September 6, 2018

Re: **Two 3,000-gallon tanks and related secondary treatment  
Gran Moraine Winery (PWS #95573)  
Conditional Approval (Plan Review #101-2018)**

Drinking Water Plan June 23, 2018

## SITE MAP GRAN MORAINE 17090 NE WOODLAND LOOP RD YAMHILL OR

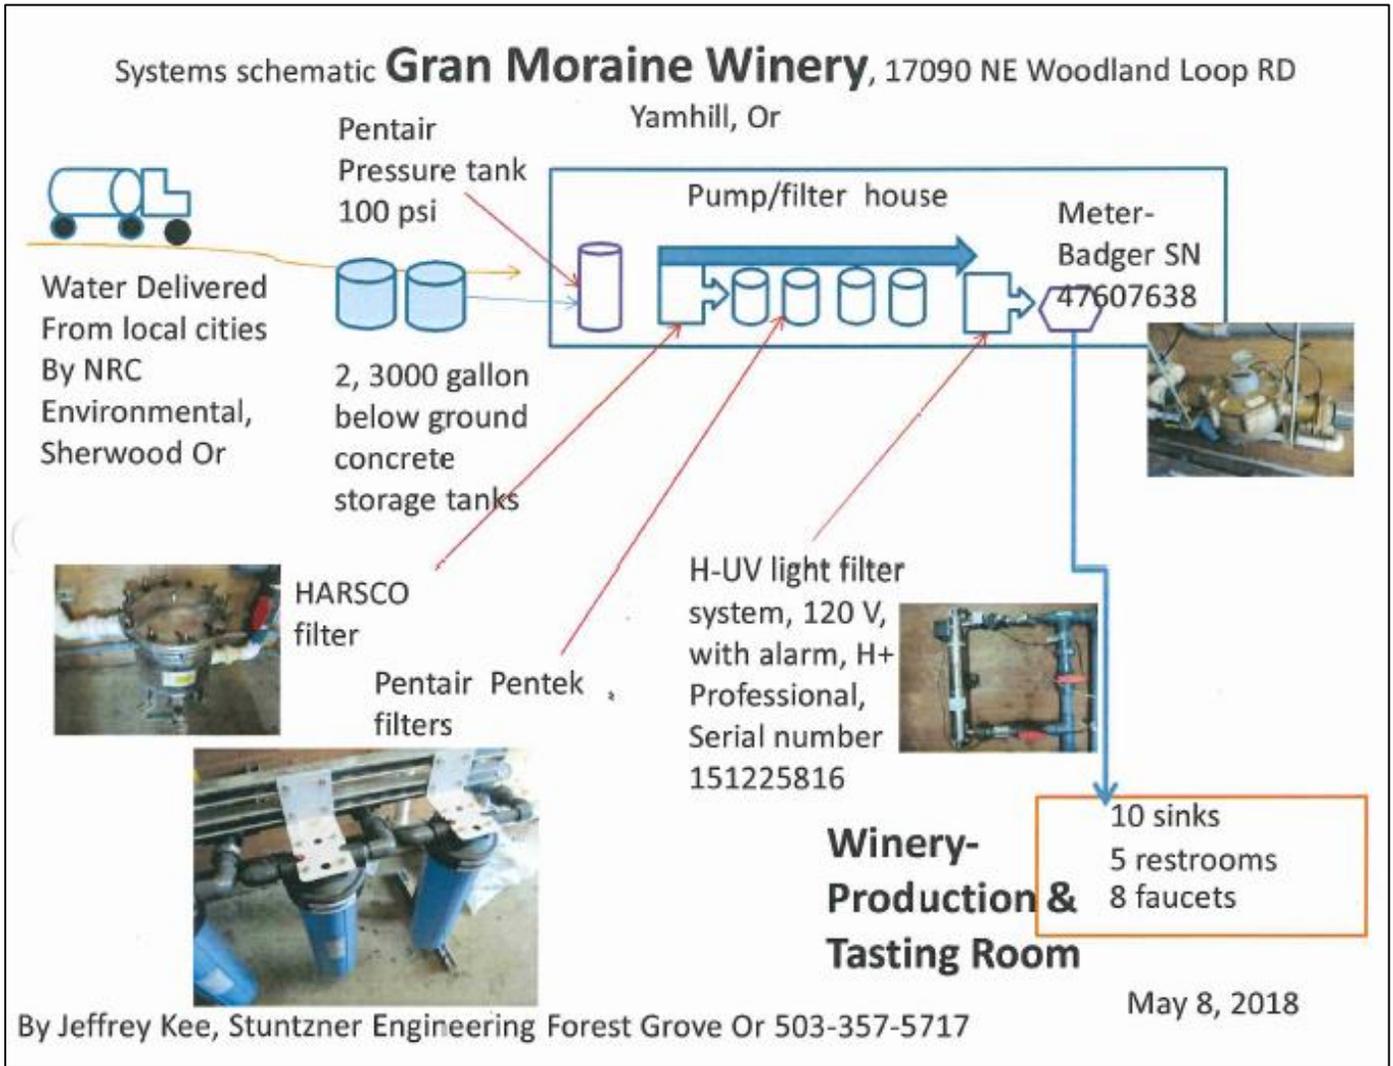
3. A raw water sample tap that allows you to sample water prior to any treatment must be present.
4. A treated water sample tap (after all treatment and typically after any pressure tanks) that is used for routine entry point sampling must also be present.

5. The tanks need to be secured such that no insects can get into them (flies can carry fecal matter into tanks if they can get into them). The tanks must have a drain and overflow which drain to daylight and have a flap valve and/or screening that prevents insect and rodent intrusion. The tanks must also have an air vent which is screened. A #24 mesh stainless screen is recommended.

6. The concrete tanks must have sufficient reinforcing to prevent the formation of cracks, and water stops and dowels shall be placed at construction joints. Poured-in-place wall castings shall be provided where pipes pass through the concrete.

7. Since the tanks are at least partially below ground, the bottom of the tanks must be above the ground water table and footing drains discharging to daylight must be provided to carry away ground water which may accumulate around the perimeter of the tanks;

8. The concrete tanks must be equipped with a lockable watertight access hatch for cleaning and maintenance, a watertight roof, fence or other method of vandal deterrence, and an internal coating (if present) that meet NSF Standard 61.

10. The existing “on-site” well mentioned in the “General Description” of the June 23, 2018 Drinking Water Plan must be physically disconnected from the system supplying potable water, since it has not been approved for use and may have potential contamination issues (e.g., connection to underground irrigation piping, process chemicals, and/or pesticide application facilities). A removable spool (can be made from flanges and gaskets) or piping that accommodates a short segment of hose will provide this separation and will make some allowance for an emergency connection if needed in the future.
